**VILLAGE OF ORLAND PARK**  
**APPEARANCE IMPROVEMENT GRANT AGREEMENT**

File Number: 2018-0774

Macy's LED Lighting Upgrade - Appearance Review

Macy's LED Lighting Upgrade - 2018-0774

Simon - Grand Square  
Featuring Height: 40' x 120'  
Horizontal FC's at Road

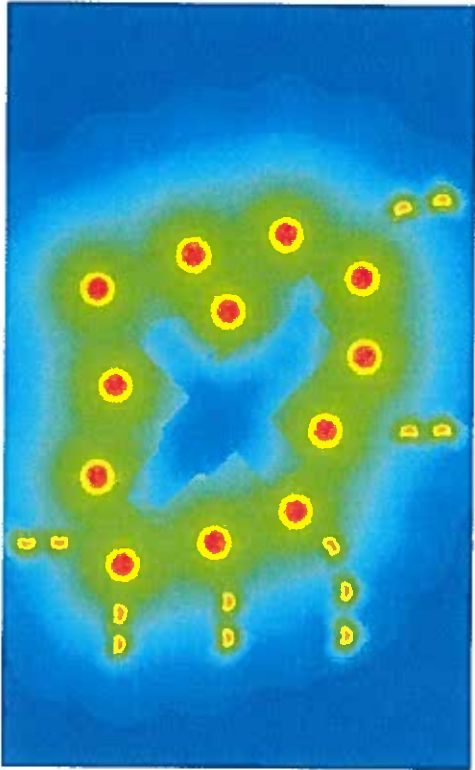
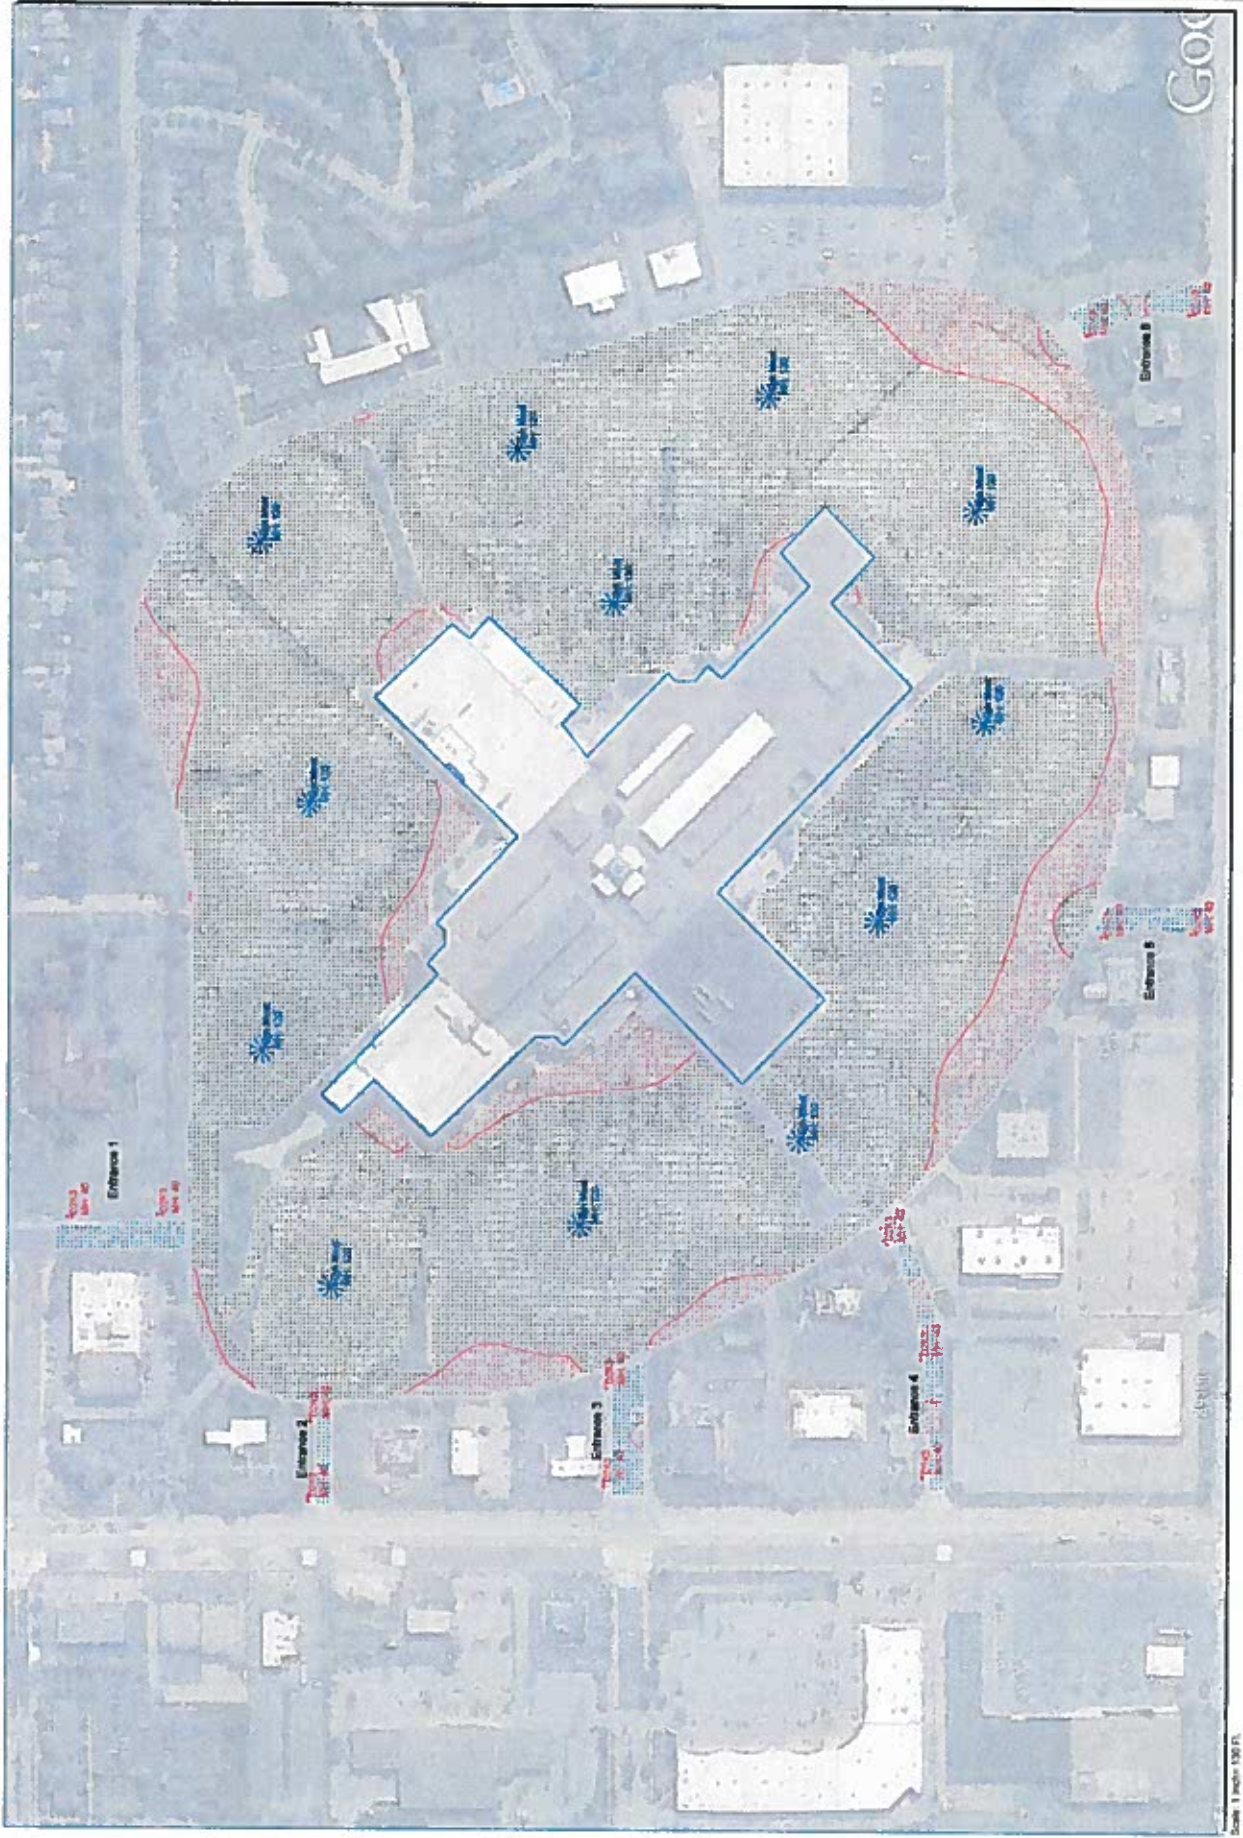
- 1) Provide confirmation that the footcandles and lumens per square foot on the Photometric Plan do not exceed the specified maximum limitations within Section 6-315.A.2.a.1. or revise the Photometric Plan to comply with said requirements;
- 2) Meet all Building and Land Development Code requirements; and
- 3) Obtain the necessary permits from the Village's Building Division prior to initiating work.

The Petitioner has not yet confirmed compliance with the maximum level of footcandles and lumens/sf per Section 6-315.A.2.a.1. of the Land Development Code. Compliance with these regulations is required as a condition of the approval. The proposed Photometric Plan complies with all other regulations for Lighting Class 1.

- 1) Provide confirmation that the footcandles and lumens per square foot on the Photometric Plan do not exceed the specified maximum limitations within Section 6-315.A.2.a.1. or revise the Photometric Plan to comply with said requirements; and
- 2) Meet all Building and Land Development Code requirements; and
- 3) Obtain the necessary permits from the Village's Building Division prior to initiating work.
